Index 102-660 Pedestrian Control for Closure of Sidewalks

COMMENTARY

COMMENTS AND RESPONSES

LAST REVISION 11/01/20	REVISION	DESCRIPTION:	 FY 2021-22 STANDARD PLANS	SIDEWALK CLOSURE	INDEX 102-660	SHEET 1 of 2
---------------------------	----------	--------------	--	------------------	------------------	-----------------

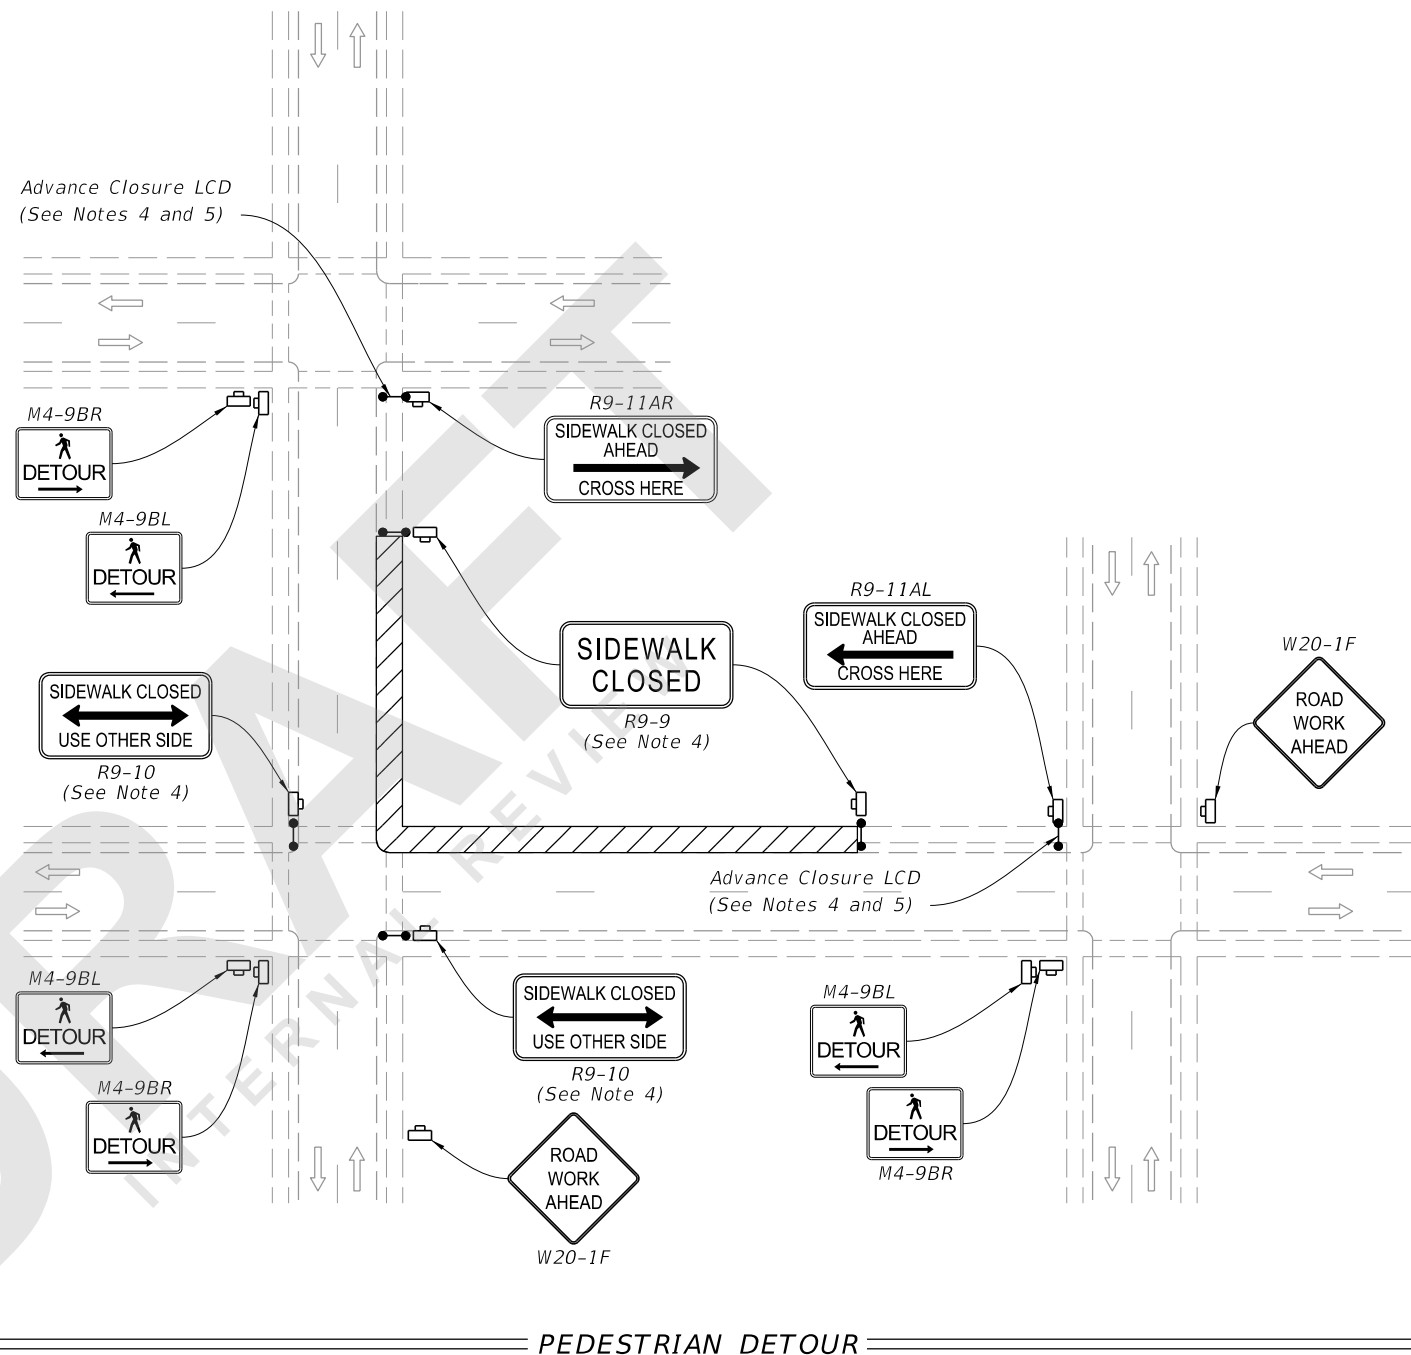
COMMENT: Sheet 1: The detour signs are confusing they only apply to a person who is trying to walk in the closed area. If I am walking on a non closed area and come to a detour sign it would send me off track. Walking south (right hand side) on eastern most road I come to a make a right detour when the south headed sidewalk is open. The extra sign on the bike lane closure that says where the closure is would be helpful.

COMMENT: Sheet1 of 2; layout shows Ped LCD’s (sidewalk closure) mid-block, recommend showing them at the intersection corner in part for visually impaired peds 615.

RESPONSE: *The signage is consistent with the MUTCD requirements/guidance. Like with motorized vehicle detours the expectation is that users acknowledge the presence of the work zone and understand the intended purpose. However, if the detour extends beyond sight of the work zone, additional consideration should be giving to adequately communicating the intent of the detour.*

RESPONSE: *MUTCD TA-28 shows a barricade at the nearest sidewalk intersection away from the closure. The assumption being that no other access point exists within the block (i.e., business, transit stop, etc.). However, TA-29 does not show an LCD or barricade. Consideration will be given to adding an option LCD at the nearest intersection/corner, provided access to other pedestrian facilities will not be affected.*

Change Made: *Added LCD at nearest corner along with Note “5. Omit the Advance Closure LCD if it blocks access to other pedestrian facilities (e.g., transit stops, residences, or business entrances).”*

LAST REVISION 11/01/20	REVISION	DESCRIPTION:		FY 2021-22 STANDARD PLANS	SIDEWALK CLOSURE	INDEX 102-660	SHEET 2 of 2
---------------------------	----------	--------------	--	------------------------------	------------------	------------------	-----------------

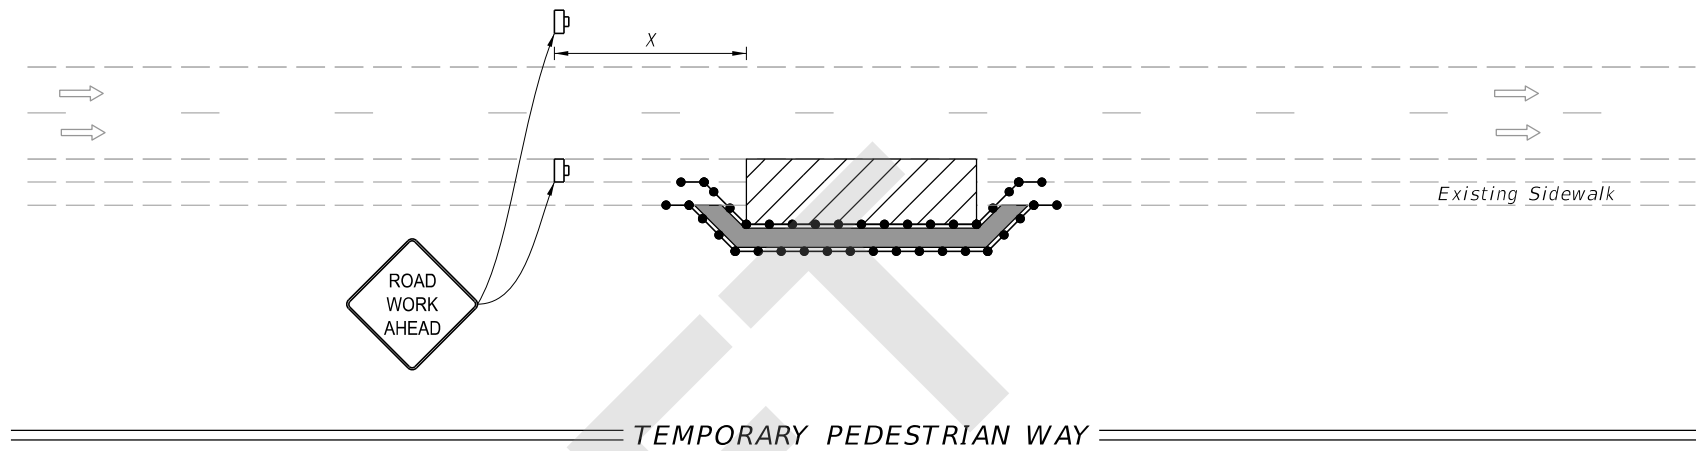
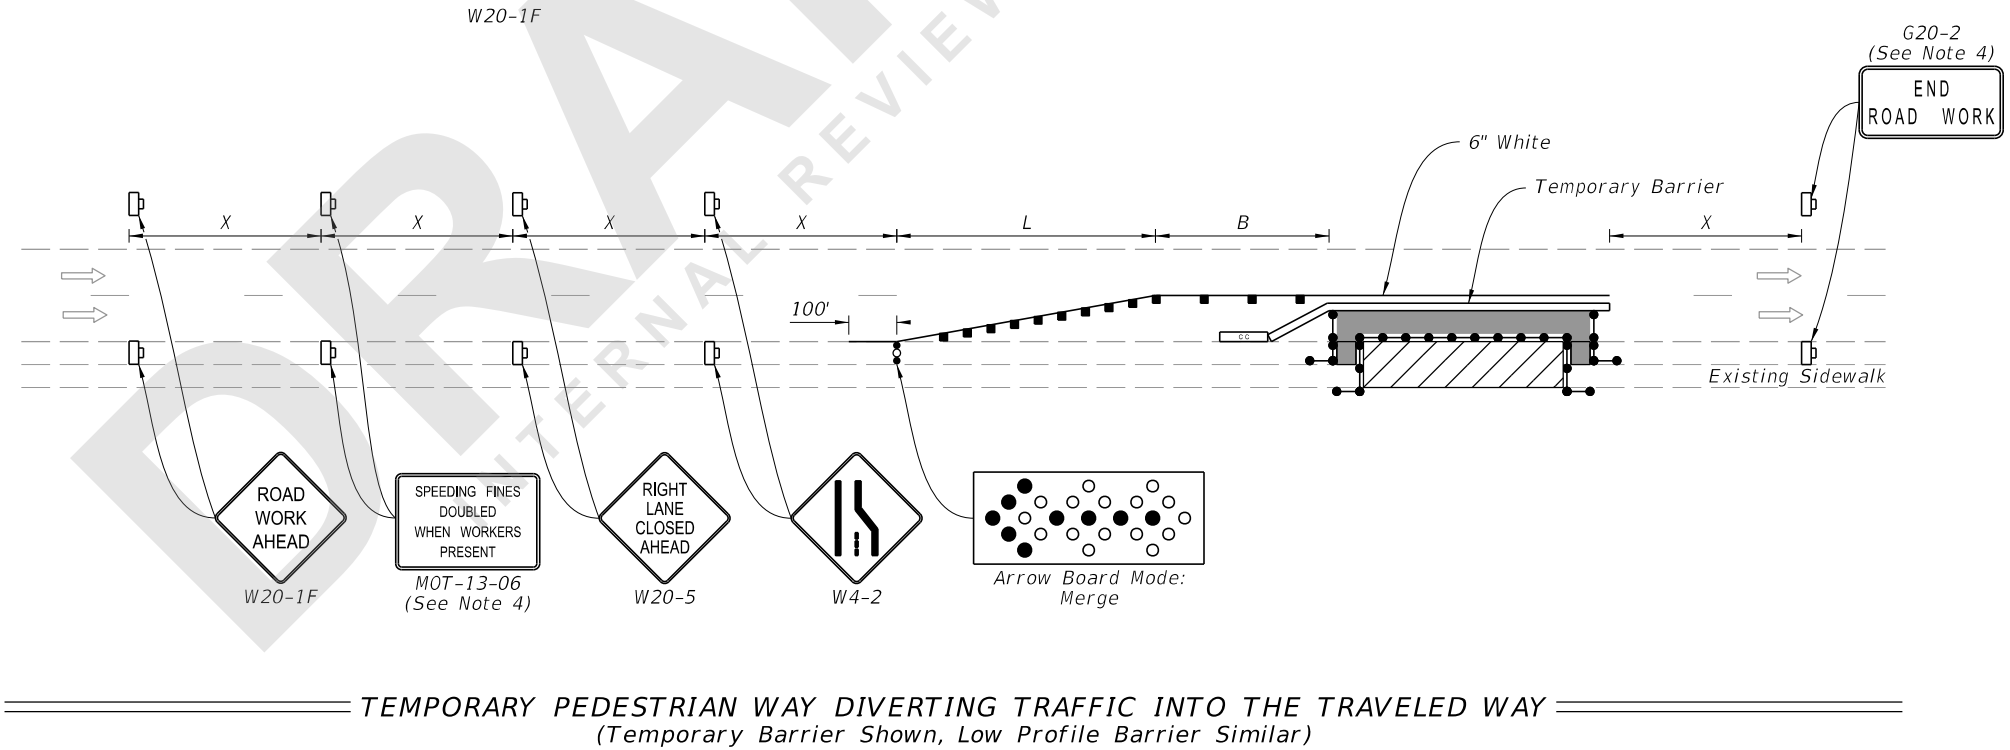
1. 102-660. Sheet 2/2. Note 3. Second line – This may not comply with ADA and consider delete

2. 102-660. Sheet 2/2. Bottom Typical Label – (Temporary Barrier Shown, Low Profile Barrier Similar) – Low Profile Barriers are 18” tall and may not meet height requirement for ADA and consider deleting Low Profile Barrier because Temp Barrier will meet requirement.

COMMENT: Sheet 2: Consider adding note for temporary barrier to meet pedestrian LCD requirements as noted in Index 102-600, Sheet 10, Note 9. Not all temporary barriers provide the continuous detectable edge or hand trailing rail. LPBW will require pedestrian LCDs to be implemented on back side of LPBW.

1. Footnote says “low profile barrier similar”, but is low profile barrier height (18”) adequate for delineating one side of a pedestrian path? It seems to low.

2. Graphic shows the temporary barrier placed directly adjacent to the pathway without providing deflection space. Is this the intent? Or should deflection space be provided between the wall and path?

RESPONSE: *Mounting “Sidewalk Closed” signs directly to the Pedestrian Longitudinal Channelizing Device (LCD) does not violate any ADA requirements. However, not all LCD’s can have signs mounted to them, and if one of them is used, a separate sign support/stand would be needed.*

RESPONSE: *ADA requirements would not control, as there would be no drop-off between the pedestrian way and motorized traffic. In accordance with FDM 215, Low Profile Barrier would only be used in low speed work zones with frequent intersections/driveways. This is done to provide better sight distance for drivers, which*

would include visibility of pedestrians. Therefore, to balance the safety for all users, low profile barrier is allowed for in these conditions.

RESPONSE: *In accordance with FDM 215, Low Profile Barrier would only be used in low speed work zones with frequent intersections/driveways. This is done to provide better sight distance for drivers, which would include visibility of pedestrians. Therefore, to balance the safety for all users, low profile barrier is allowed for in these conditions.*

RESPONSE: *In accordance with FDM 215, Low Profile Barrier would only be used in low speed work zones with frequent intersections/driveways. This is done to provide better sight distance for drivers, which would include visibility of pedestrians. Therefore, to balance the safety for all users, low profile barrier is allowed for in these conditions.*

RESPONSE: *Similar to permanent barriers (e.g., guardrail) deflection space of roadside barriers is typically not required between the roadway and a pedestrian facility, nor are barriers required for separation of the traveled way and sidewalks. We include them in this specific TTC condition because of the change in traffic pattern and the absence of curb.*
